Access Compliance Report

Public Rights-of-Way

Intersection ID: 21061	Main Street: SARDIS_RD	Cross Street: SMITHFIELD_DR	Location: NW
ADA ID: F8E32758760F	Ramp Type: PerpDiag	Initial Pass/Fail: Fail	Overall Compliance: No
		Severity Score: 12.5

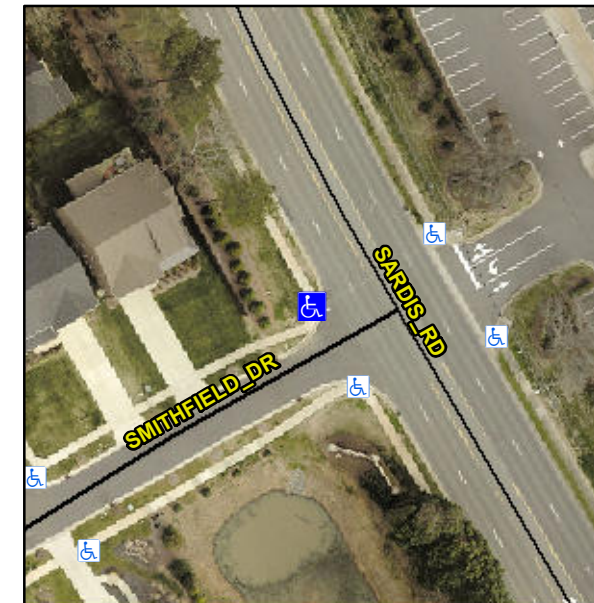
R304.5.3

Compliance	Description	Data	Compliance	Description	Data
N/A	Ramp Length (in)	62.0	Yes	Ramp Slope (%)	5.0
Yes	Ramp Width (in)	54.0	No	Ramp XSlope (%)	5.2
N/A	Flare Type LT	N/A	N/A	Flare Type RT	N/A
N/A	Flare Slope LT (%)	N/A	N/A	Flare Slope RT (%)	N/A
N/A	Flare Traversable LT?	N/A	N/A	Flare Traversable RT?	N/A
N/A	Landing Length (in)	N/A	N/A	DWS Provided?	N/A
N/A	Landing Width (in)	N/A	N/A	DWS Contrast?	N/A
N/A	Landing Slope (%)	N/A	N/A	DWS Length (in)	N/A
N/A	Landing X Slope (%)	N/A	N/A	DWS Full Width?	N/A
N/A	Landing Curb? (Y/N)	N/A	N/A	DWS Offset (in)	N/A
N/A	Shared Landing?	N/A			
N/A	Gutter Ponding?	N/A	N/A	Gutter Slope (%)	N/A
N/A	Gutter Lip Ht (in)	N/A	N/A	Gutter X Slope (%)	N/A
N/A	Painted X Walk1?	No	N/A	Painted X Walk2?	No
	X Walk 1 Direction	To SE		X Walk 2 Direction	To NE
N/A	X Walk 1 Width (in)	N/A	N/A	X Walk 2 Width (in)	N/A
	X Walk 1 Slope (%)	2.0		X Walk 2 Slope (%)	5.2
	X Walk 1 X Slope (%)	2.0		X Walk 2 X Slope (%)	1.7

Remove & Replace Curb Ramp With Two New Directional Ramps or Equivalent.
